Contract #: 04-0120F4Cty: SF/ALA Rte: 80 PM: 13.2/13.9File #: 69.25B**QUALITY ASSURANCE -- NON-CONFORMANCE REPORT****Location:** Changxing Island, Shanghai, P.R. China**Report No:** NCR-000500**Prime Contractor:** American Bridge/Fluor Enterprises, a JV**Date:** 01-Nov-2009**Submitting Contractor:** Zhenhua Port Machinery Company, Ltd (ZPMC), Changxing Island**NCR #:** ZPMC-0473**Type of problem:****Welding****Concrete****Other****Welding****Curing****Procedural****Bridge No:** 34-0006**Joint fit-up****Coating****Other****Component:** Lift 12 OBG Floor Beams**Procedural****Procedural****Description:****Reference Description:** Out of Flatness Floorbeam components for Lift 12 due to Improper Handling and Storage**Description of Non-Conformance:**

Job Name: SAS Superstructure

Subject: NCR No. ZPMC-0473

Reference Description: Out of Flatness Floorbeam components for Lift 12 due to Improper Handling and Storage

FB3069-002 @ 12CW PP115.5

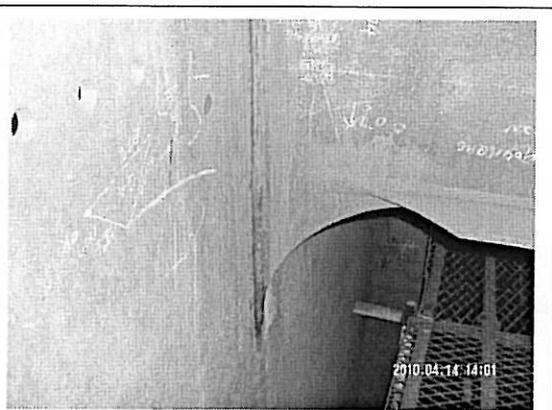
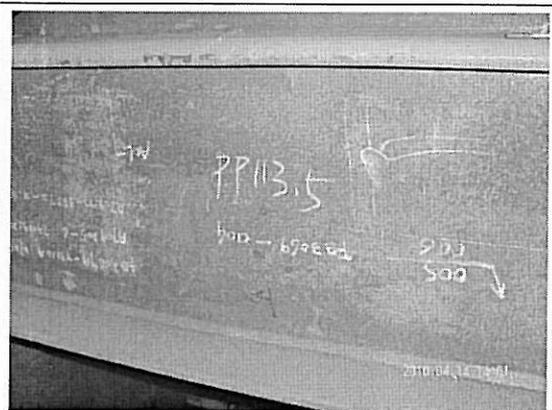
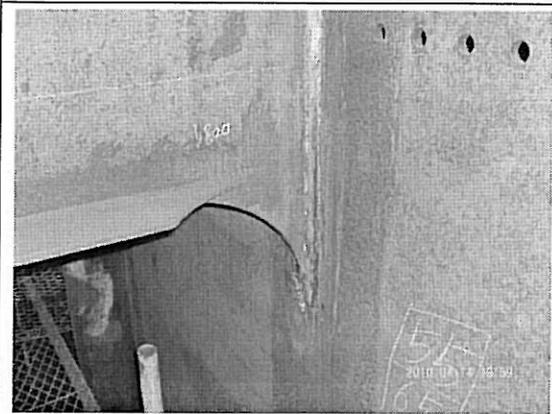
The Caltrans Quality Assurance (QA) Inspector observed lift 12 Floor Beam components located in Bay 2 that were out of flatness and have been bent due to improper handling and storage. These Floor Beam components were identified as FB3007-002, FB3069-004 and FB3069-002.

ZPMC acknowledged this issue and has released an internal NCR. Heat Straightening was performed to rectify the distortion caused by the unsatisfied storage. These panels have now been assembled into segment as showed in the following pictures. ZPMC is providing the HSR1 report and the NDT record shows the soundness of metal after heat straightening and is requesting closure of this NCR.

Heat Straightening Record(HSRI)

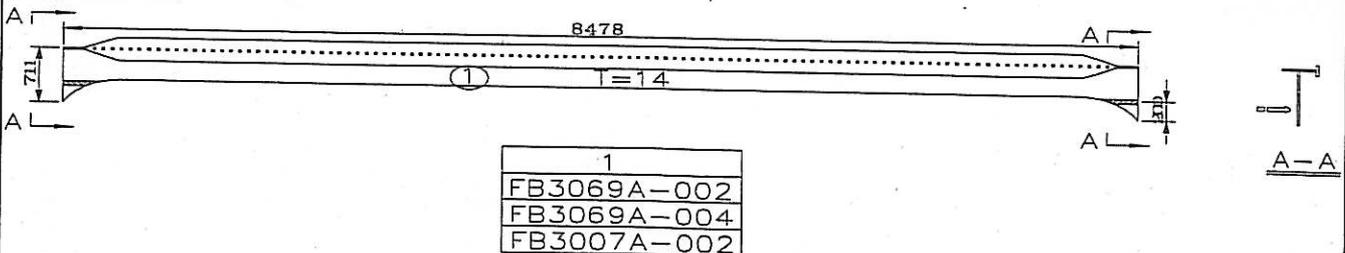
Cause 原因	Bounce distortion 撞击变形
Type of Defect 缺陷类型	Bounce distortion 撞击变形
Inspection Method 检查方法	Visual 目检

缺陷去除方法(Defect Removal Method):	natural gas 天然气
后续NDE(Post-Removal NDE):	After finishing heat straightening, the weld of the heat area shall perform NDT according to the approved shop drawing 校火后, 根据图纸要求对热影响区域进行NDT检测.
纠正措施(Corrective Action(s)):	Control current, voltage and weld speed according to relevant WPS. If necessary anti-deformation or hold down device can be added. 依据相应的WPS的要求控制电流, 电压和焊接速度. 如有必要, 可使用反变形设施进行校正.
实施次数(Number of application):	1~3
最高温度(Maximum temperature):	<650°C
